PRODUCT CHANGE NOTICE

PCN24-067

PGA-32-75-DF+
PGA-32-75-DG+
PGA-32-75-DP+

Figure 1. PGA-32-75-D+ Functional Diagram

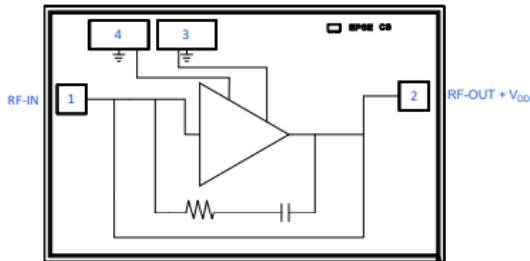
Change of Application Note and Pad Description to remove Pads 3 & 4 as “optional” ground connections. Failure to do so will result in an inoperable part.

Function	Pad Number	Application Description (Refer to Figure 3)
RF-IN	1	RF-IN pad connects to RF Input port.
RF-OUT + V _{DD}	2	RF-OUT pad connects to RF Output port and voltage input port, V _{DD} .
GND	3,4	Connects to die backside through vias. Bond wires to ground are optional.
